Preliminary Consultation
MONTGOMERY COUNTY HISTORIC PRESERVATION COMMISSION
STAFF REPORT

Address:	9220 Damascus Hills Lane, Damascus	Meeting Date:	5/8/2024
Resource:	Master Plan Site #11/21 <i>(Rezin Bowman Farm)</i>	Report Date:	5/1/2024
Applicant:	Daniel Ferenczy	Public Notice:	4/24/2024
Review:	Preliminary Consultation	Tax Credit:	No
Case Number:	1067189 RETROACTIVE	Staff:	Chris Berger

PROPOSAL: Retroactive review of fenestration and lights replacement; window openings in the gable ends and installation of composite windows; and fence construction.

Figure 4: This cropped Vintage Aerial photo from 1973 show the Milk House before the façade was altered.

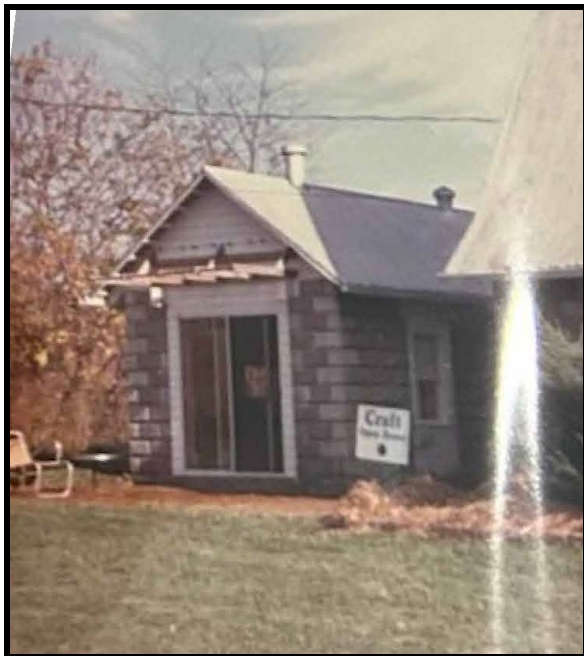
The applicant installed a composite sliding door on the front elevation (*Figures 3 and 10*). The Shaker Gliding 2/3 Lite door replaced the remnants of the double metal sliding doors on the front elevation. It is paneled with large, single lites on each of the doors. The archival photo from 1973 shown in *Figure 4* shows a window on the elevation. It is likely a sliding metal door was installed shortly thereafter when the building transitioned to a new use but prior to its historic designation in 2009. Staff supports the composite material of the door because it was placed in an opening created before the building's designation as a Master Plan Historic Site. The door is compatible to the design of the Milk House; the length and width of the lites approximate the size of the windows present on the building and is compatible with the building.

The applicant replaced two light fixtures on the front elevation on either side of the sliding doors, and one fixture was installed on the right-side elevation at the door (*Figure 10*). Each fixture measures approximately 8 inches long and is of a simple design that includes a clear glass shield containing an LED lightbulb and a circle-shaped housing attached to the building.

Figure 11: The openings and windows newly installed in the gable ends are circled.

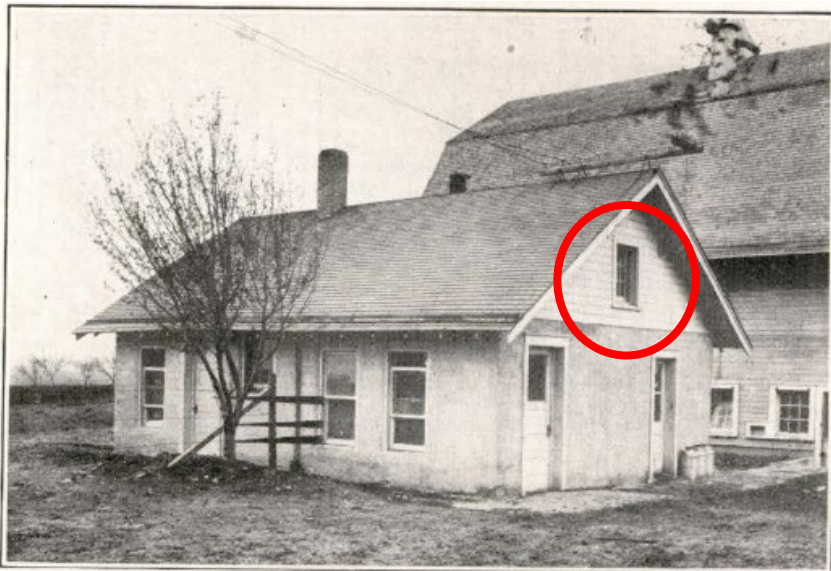
The applicant said he installed the window openings and Anderson Fibrex windows measuring 18-by-24 inches in the gable ends to provide light and ventilation to the building (*Figure 11*). The openings are centered in the gable ends, just under the roofline. While staff does not support the trim, as is detailed later in this report, staff does support the new openings and corresponding windows. Staff supports the material of the windows because they are new to the building and did not replace previously installed windows. The windows are appropriately sized for the building and were placed in the wood siding and not the historic masonry. The windows improve the functionality of the space as it is further adapted from its original, utilitarian use. Staff notes there is precedent for windows in gable ends in milk houses; staff

found a photo of an early 20th century milk house similar in design to Rezin Bowman Milk House with a small window in the gable end (*Figure 12*).

Staff does not support the size of the wood trim around the new windows in the gable ends (*Figure 16*). While staff supports the new window openings and composite windows, the approximately 6-inch wide trim around the 18-by-24-inch windows is too large and bulky for the small windows and not compatible to the small structure as it covers up much of the historic wood lap siding. Staff recommends the trim is significantly reduced in width.
